U.S. Department of the Interior BUREAU OF LAND MANAGEMENT

Sundry Print Reports

Well Name: LOST TANK 30-19 Well Location: T22S / R32E / SEC 19 / County or Parish/State: LEA /

Type of Action: APD Change

Wellhead diagram during offline cementing operations

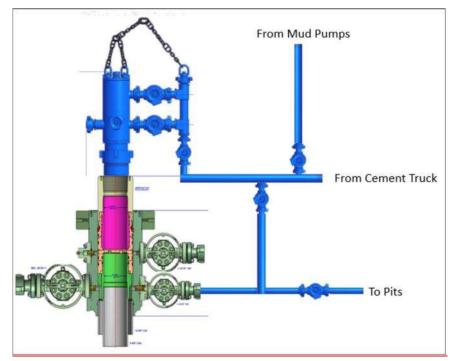
- 6. Skid rig to next well on pad.
- 7. Confirm well is static before removing cap flange, flange will not be removed and offline cementing operations will not commence until well is under control. If well is not static, casing outlet valves will provide access to both the casing ID and annulus. Rig or third party pump truck will kill well prior to cementing or nippling up for further remediation.

- 8. Install offline cement tool
- 9. Rig up cement equipment

General well schematic:

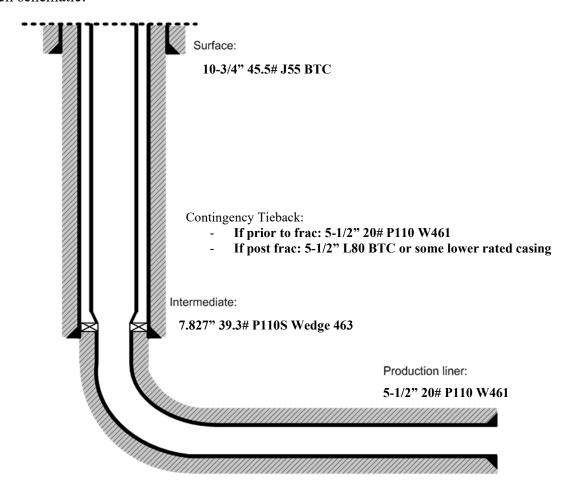
- Drill 14-3/4" hole x 10-3/4" casing for surface section. Cement to surface.
- Drill 9-7/8" hole x 7.827" casing for intermediate section. Cement to surface.
- Drill 6-3/4" hole x 5-1/2" liner for production section. Cement to top of liner, 100' inside 7.827" shoe.
- Release drilling rig from location.
- If contingency tieback required pre-frac:
 - Move in workover rig and run a 5-1/2" 20# P110 Wedge 461 tie-back frac string and seal assembly. Tie into liner hanger Polished Bore Receptacle (PBR) with seal assembly.
 - o Pump hydraulic fracture job.
 - Flowback and produce well.
- If contingency tieback required post-frac:
 - o Move in workover rig and run a 5-1/2" L80 BTC or lesser rated tie-back string and seal assembly. Tie into liner hanger Polished Bore Receptacle (PBR) with seal assembly.
 - o Return well to production.
